**RE: ENGINEER'S CERTIFICATION FOR LOTS 15 AND 16, BLOCK 3,
TRACT 2, UNIT 1, NORTH ALBUQUERQUE ACRES,(C22/D38)(PWD-94-
38), ENGINEER'S STAMP DATED 9/26/95.**

RE: DRAINAGE PLAN FOR LOTS 15 & 16, BLOCK 3, TRACT 2 UNIT 1, NORTH
ALBUQUERQUE ACRES (C22-D38) (PWD 94-38) RESUBMITTED FOR FINAL PLAT &
BUILDING PERMIT APPROVAL, ENGINEER'S STAMP DATED 8/12/94.

GRADING AND DRAINAGE PLAN
LOTS 15 & 16 BLOCK 3, TRACT 2,
UNIT 1, NORTH ALBUQUERQUE ACRES
11900 EAGLE ROCK AVENUE

RE: DRAINAGE PLAN FOR LOTS 15 & 16, BLOCK 3, TRACT 2 UNIT 1, N.A.A.
(C22-D38) RECEIVED MAY 4, 1994 FOR FINAL PLAT & BUILDING PERMIT
APPROVAL.

ALTERNATIVE WALL SECTION
6" FOAM FORM FILLED WITH 3000 PSI P.C.
NO. 4 R'BAR AT 12" O.C. VERTICAL, 24" HORIZONTAL

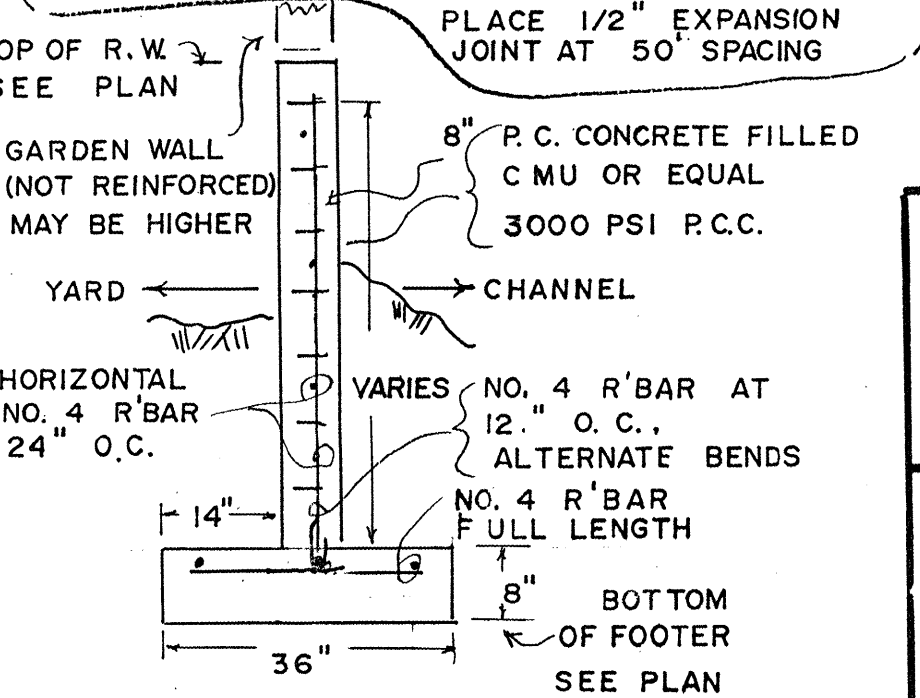
Please be advised that the scour depth at the non-parallel flood walls, located on the southeast portion of Lot 15 will need to be revised to reflect the actual flow conditions prior to release of the Building Permit for the structure

Regarding the design of the floodwall to protect the house: The angle that flow impinges on the wall (angle of attack) must consider the unconfined arroyo width and the potential for meander patterns that will change flow direction over time. In this case, the unconfined channel width is very wide and the flow is not likely to remain parallel at all times. AMAFCA's Sediment and Erosion Guide provides further guidance based on the unconfined channel width and scour. The scour depth is below the bed elevation of the arroyo. A profile of the arroyo adjacent to the flood wall must be provided to show wall elevations and channel property (sequent depth or energy grade, bed elevations, scour depth). A stability analysis of the proposed retaining wall must be provided to show that the wall will be stable at the computed scour depth.

GRADING AND DRAINAGE PLAN
LOTS 15 & 16 BLOCK 3, TRACT 2,
UNIT 1, NORTH ALBUQUERQUE ACRES
11900 EAGLE ROCK AVENUE
HEC-2 SECTION LOCATIONS

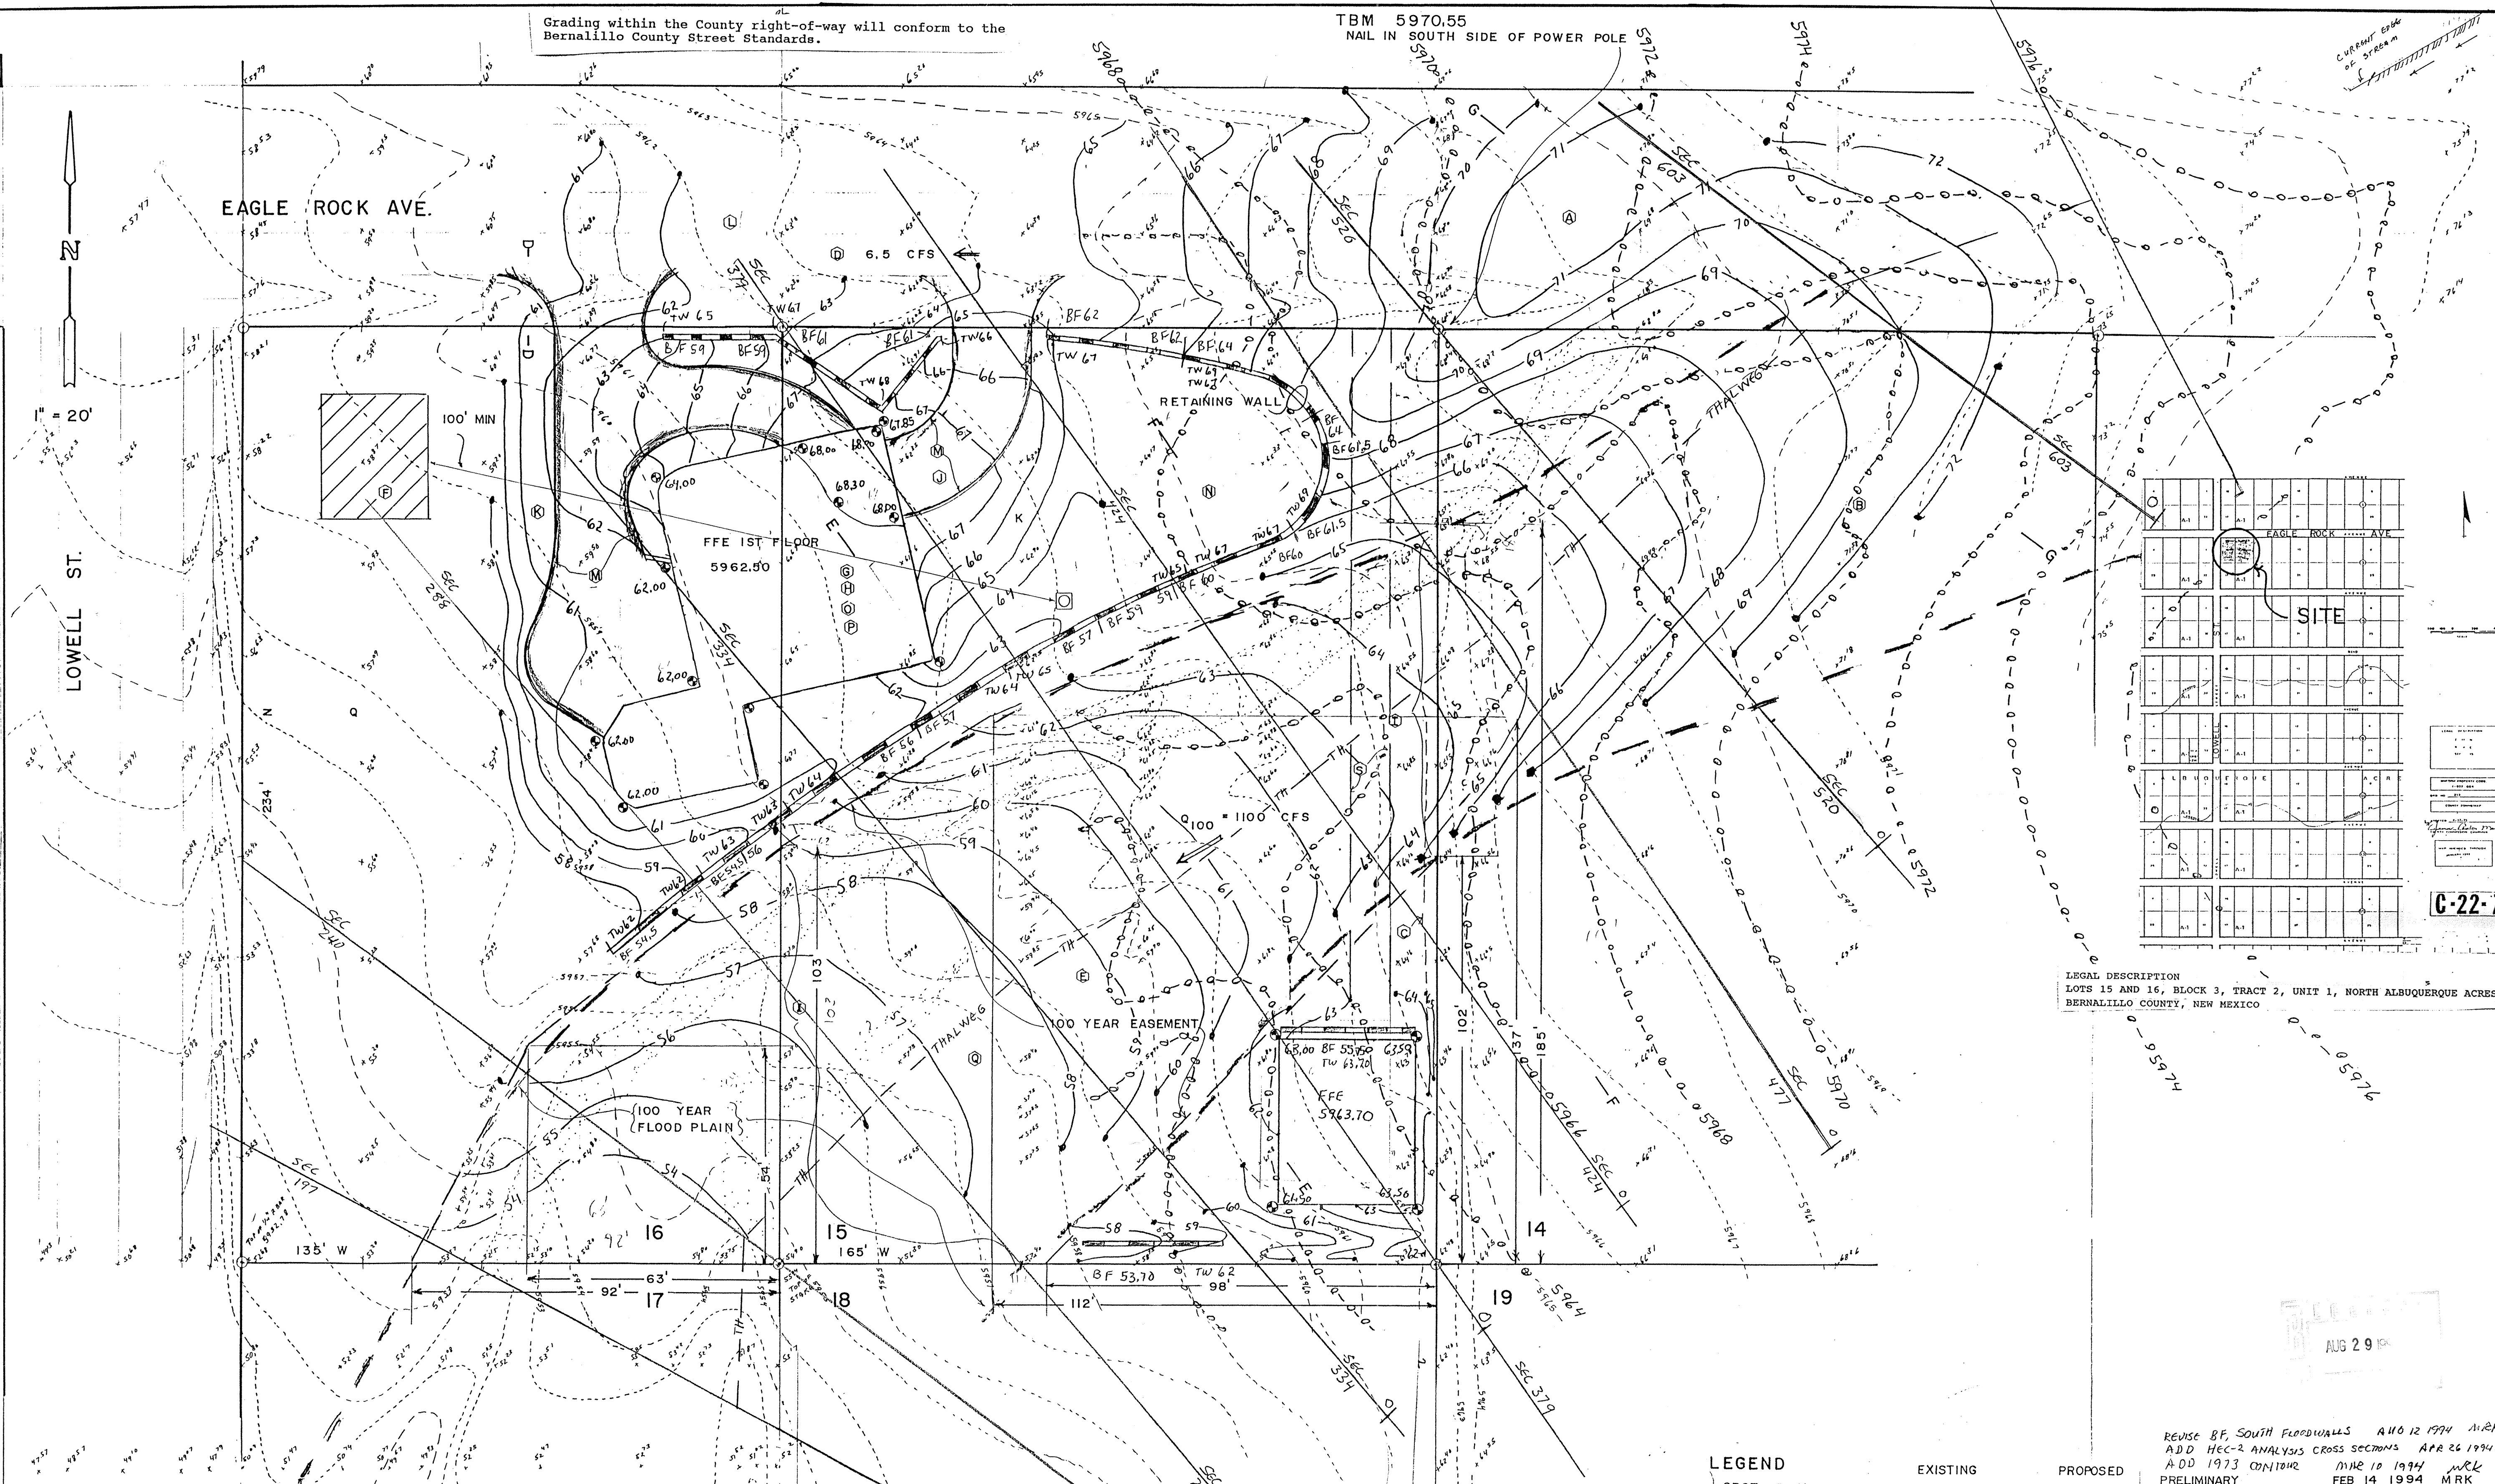
Regarding item 1 of Mr. Aldaz's letter dated 2/24/94, a HEC-2 analysis will be required to model the flow through this property to determine scour depth and flood height.

1. Due to the highly unsteady state of this arroyo and proposed encroachments and grading, a HEC-2 analysis will be required to model the flow through this property.
2. Submit written permission from the property owner for grading the offsite property on lot 14. You indicate there was illegal fill placed on this lot. Please overlay the topography from the floodway maps on the grading plan to show this activity.
3. Grading within the County Right-of-Way must conform to the County Street Standards Ordinance.
4. With the HEC-2 analysis output, evaluate the scour potential for the wall proposed with AMAFCA's erosion design guide.
5. You indicate in your notes of a berm 40 feet wide at the base and 7 feet above the invert of the existing arroyo. We could not locate this on your grading plan.

GRADING AND DRAINAGE PLAN
LOTS 15 & 16 BLOCK 3, TRACT 2,
UNIT 1, NORTH ALBUQUERQUE ACRES
11900 EAGLE ROCK AVENUE
STREET DIP PLAN AND PROFILE

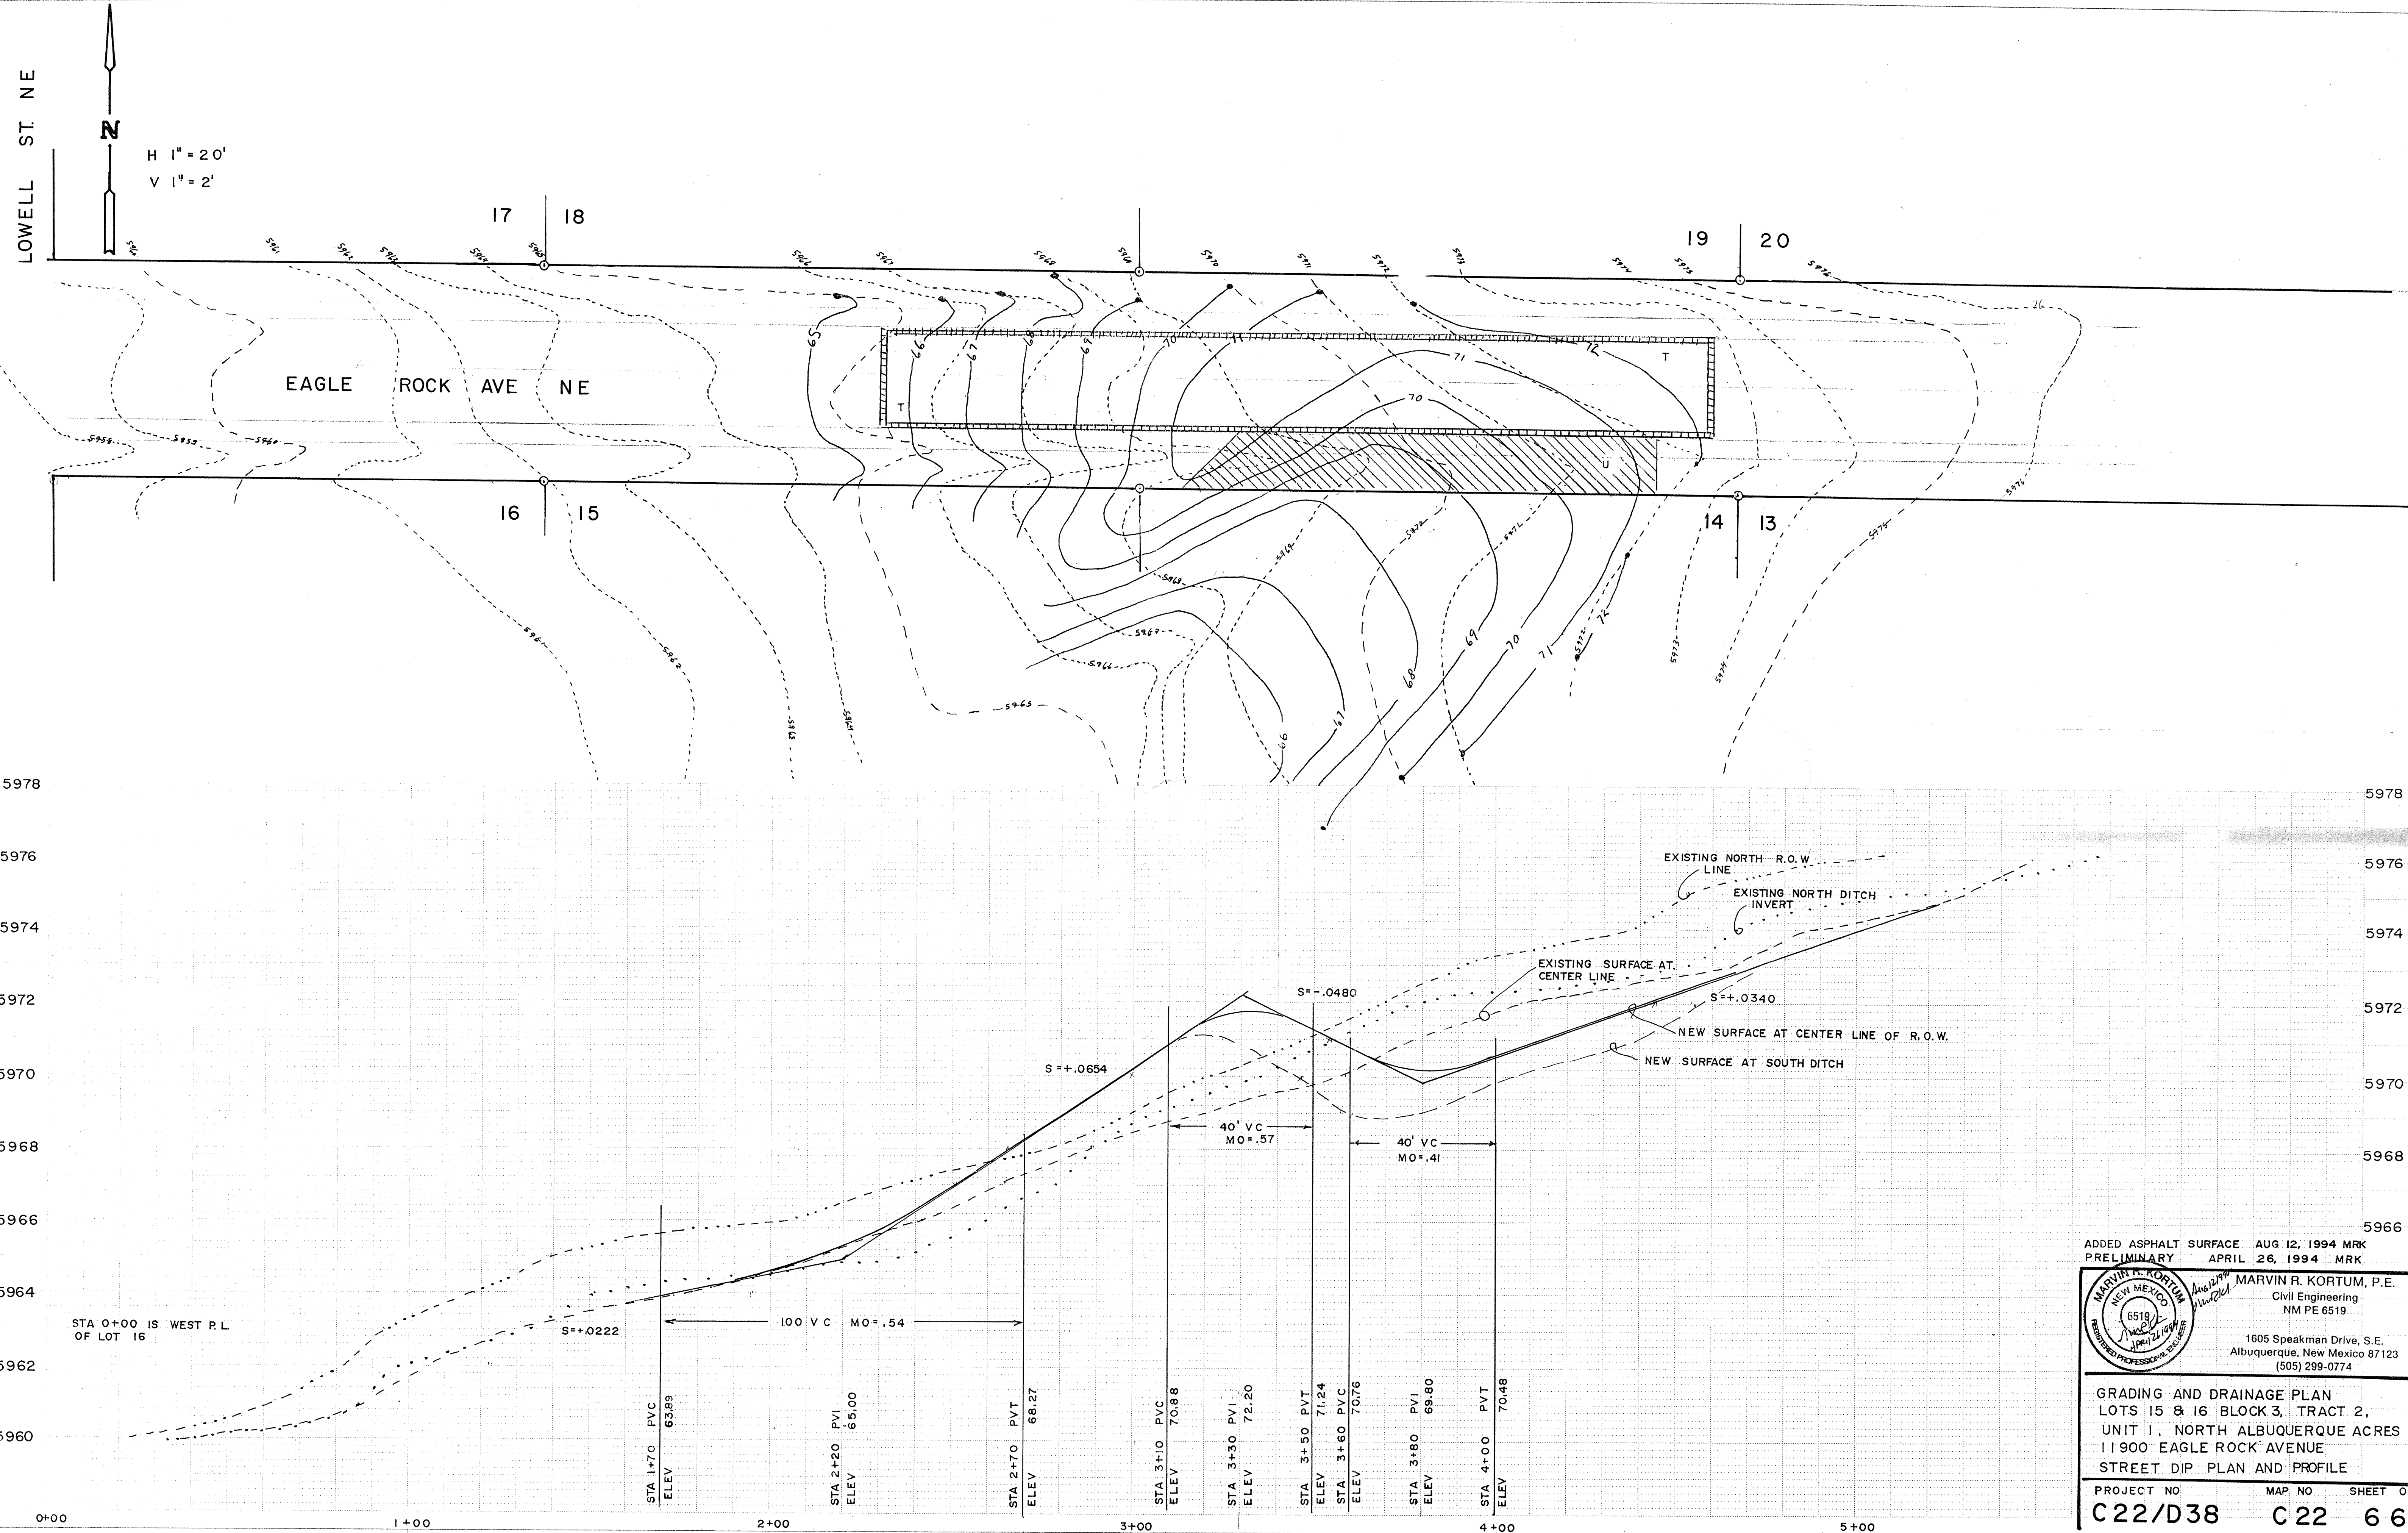
The County Public Works Department-Road Maintenance is working toward resolving the grading issues related to Eagle rock and will notify the engineer of the outcome.

Although a note has been added to the plan indicating that grading in the County Right-of-Way will conform to the County standards, the proposed contours do not appear to meet the street standards. Confirm this design with the County development review engineer, Chuck Bowman.
